Re: Minor Project Refinement No. 6 for the TL 6975 San Marcos to Escondido Project.

TL6975 San Marcos to Escondido 69 kV Project CPUC Minor Project Refinement Form

TL6975 SAN MARCOS
to ESCONDIDO PROJECT
MPR-6 Figure 1
Structure Location 78
San Diego County, CA

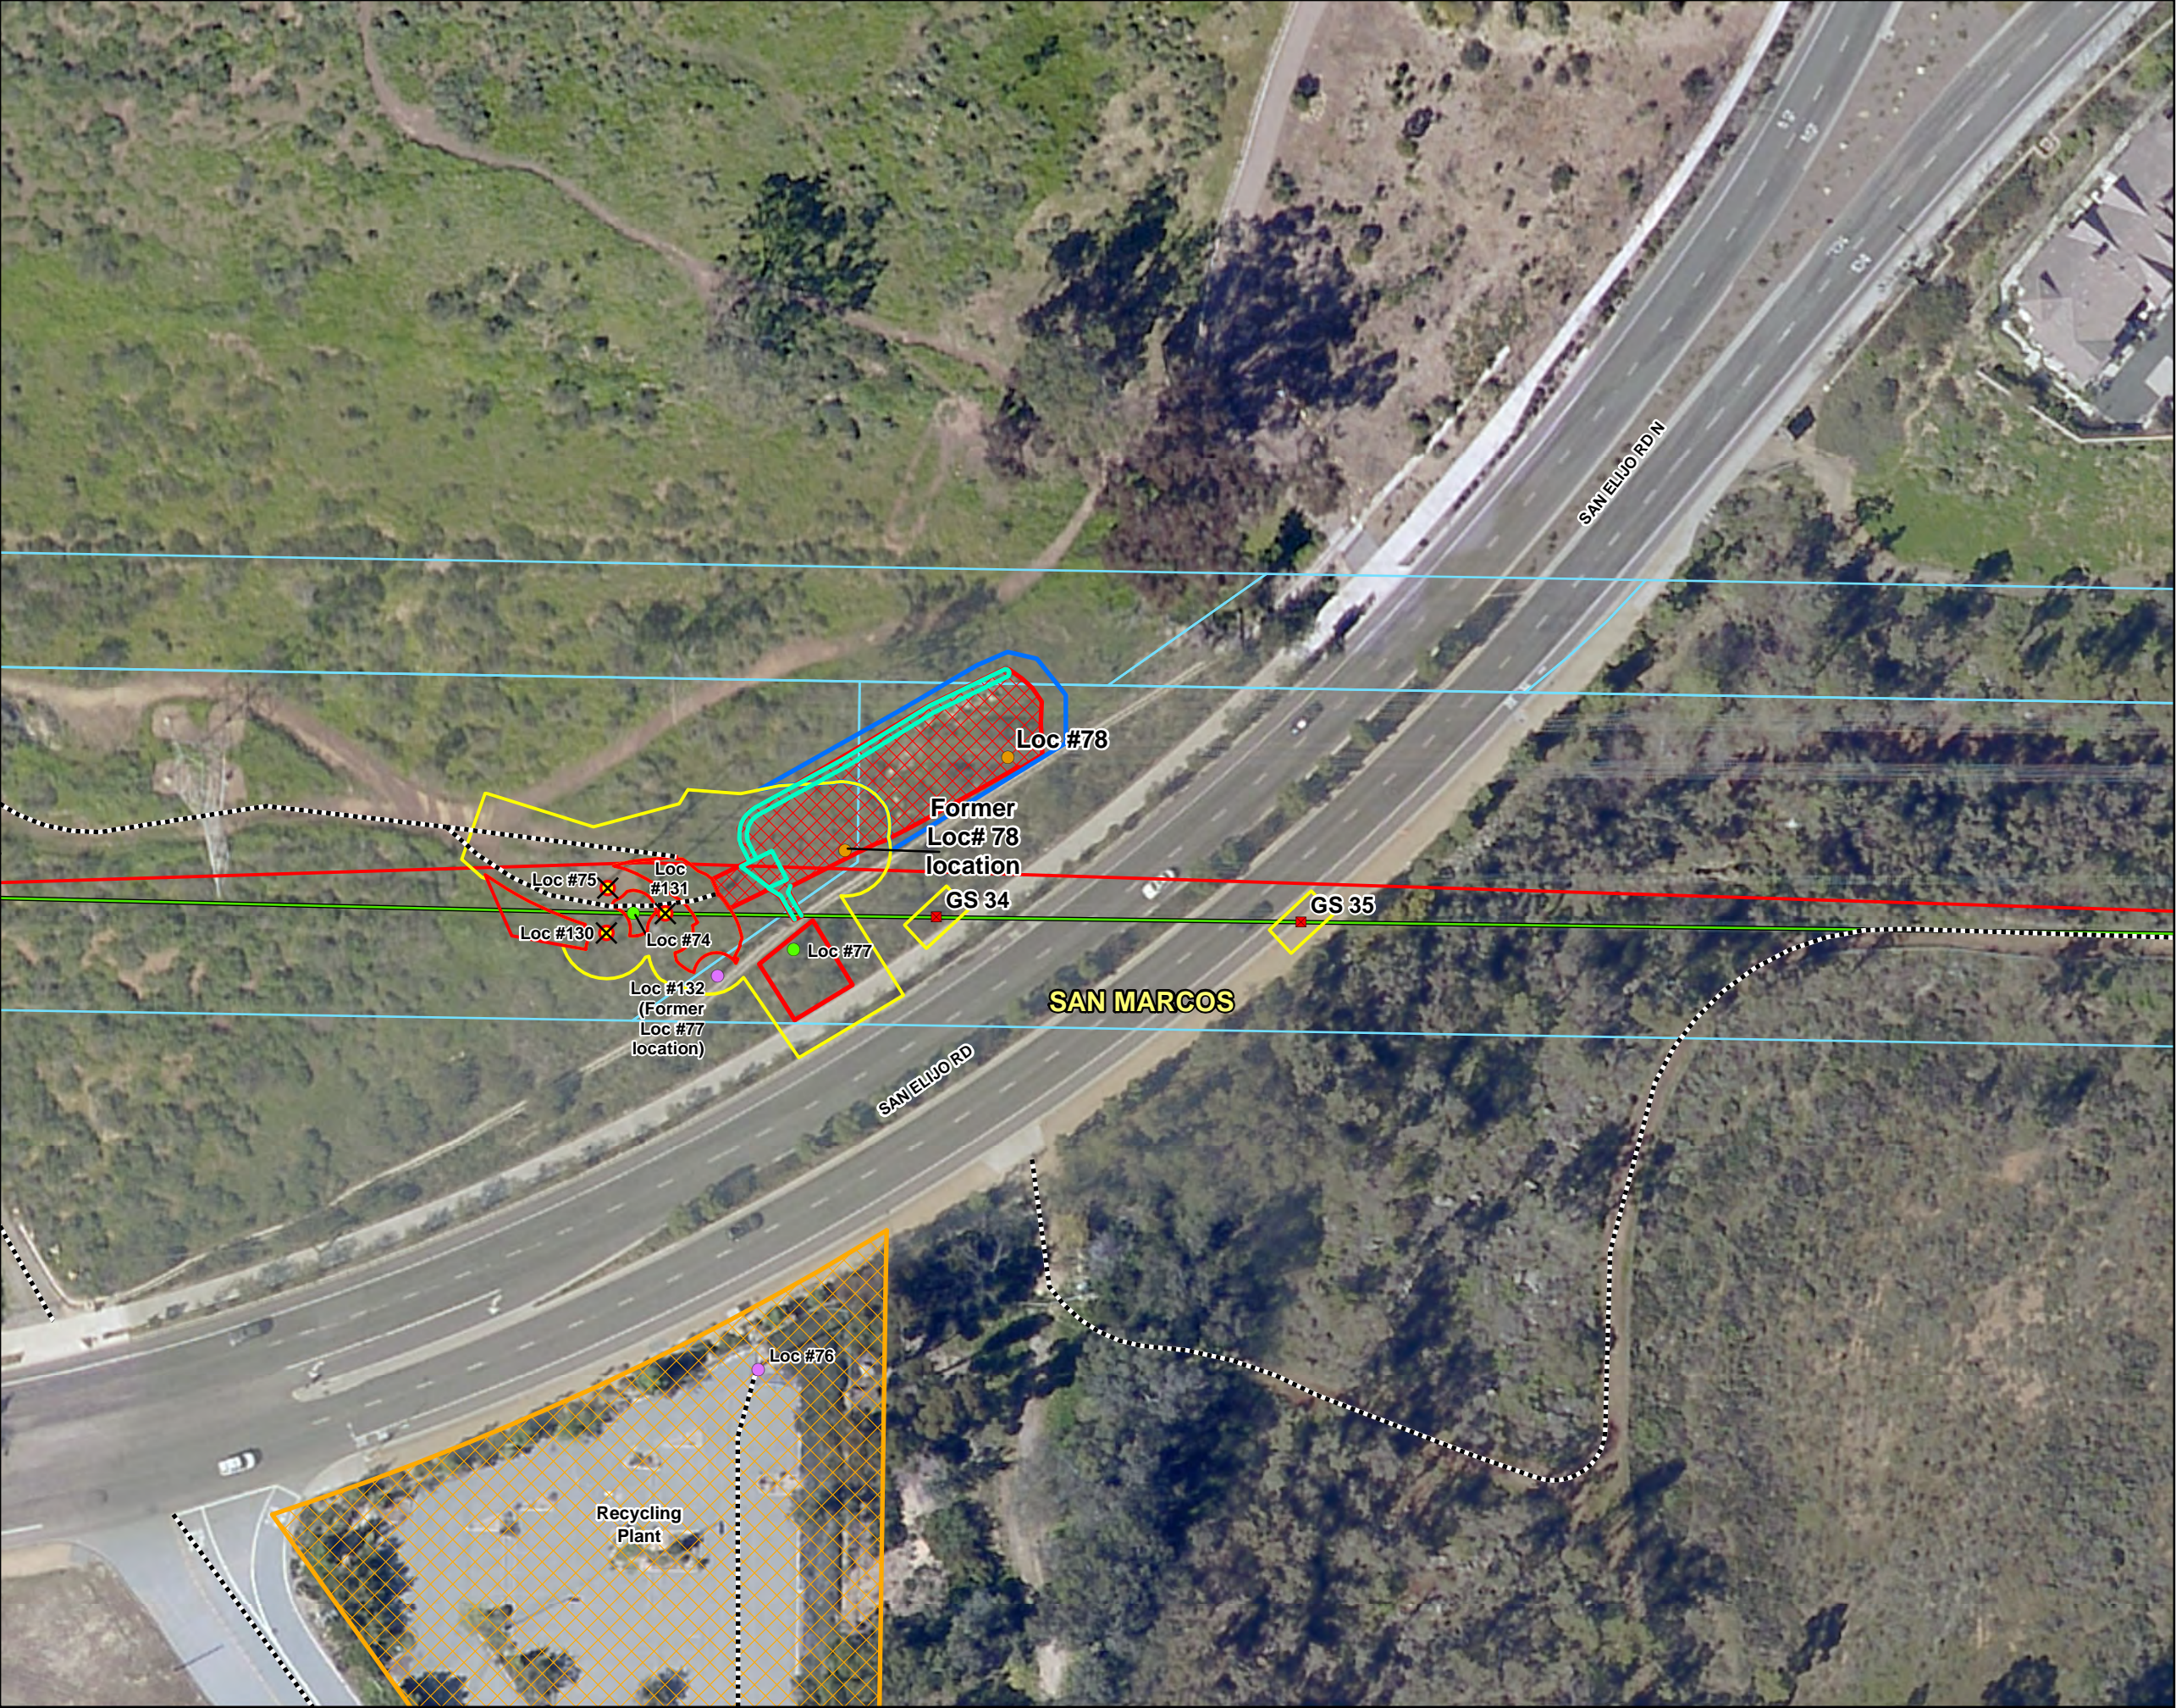
Following the approval of NTP-1, it was discovered that a regulator station was installed in the location where Location 78 was originally approved, which resulted in the reconfiguration of the overhead alignment and the relocation of Location 78. Grading will be required to create a level construction work area and permanent work pad for the new position of Location 78. In addition, a concrete brow ditch will be installed to ensure proper drainage and will connect to the existing concrete v-ditch.

MPR-6 would result in 1,340 square feet in temporary impacts and 4,750 square feet of permanent impact resulting in a total of 6,090 square feet (0.14 acre) of additional disturbance to the Project as approved.

Photograph 1:

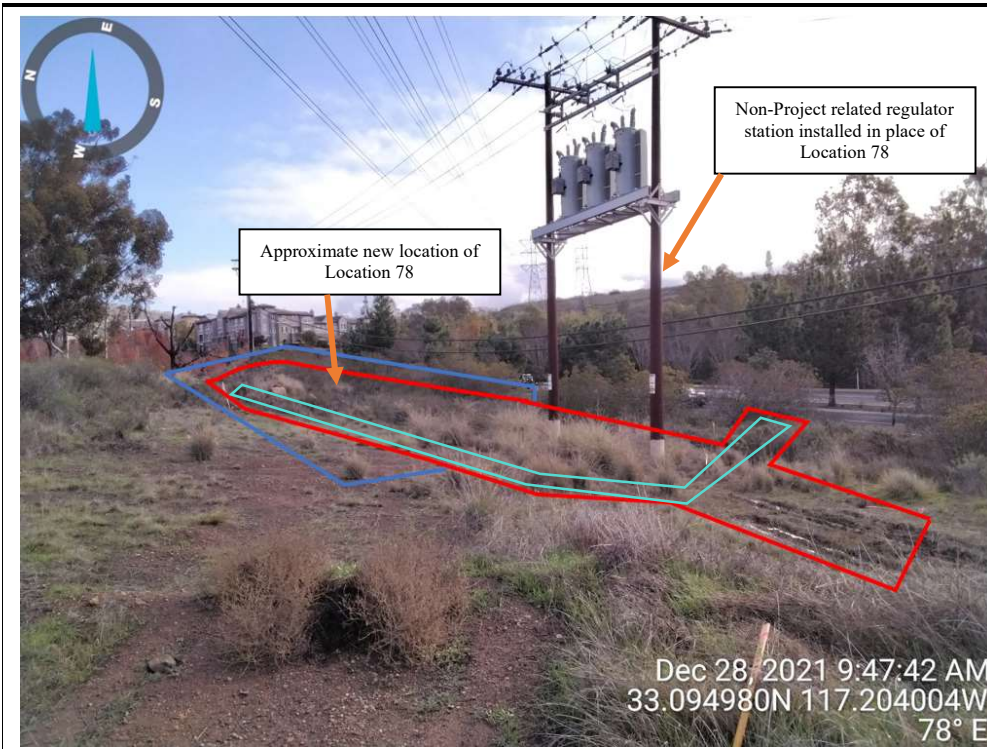
View of the MPR-6 temporary work area in dark blue, permanent work area in red and the approximate location of the brow ditch feature in teal. Facing: E
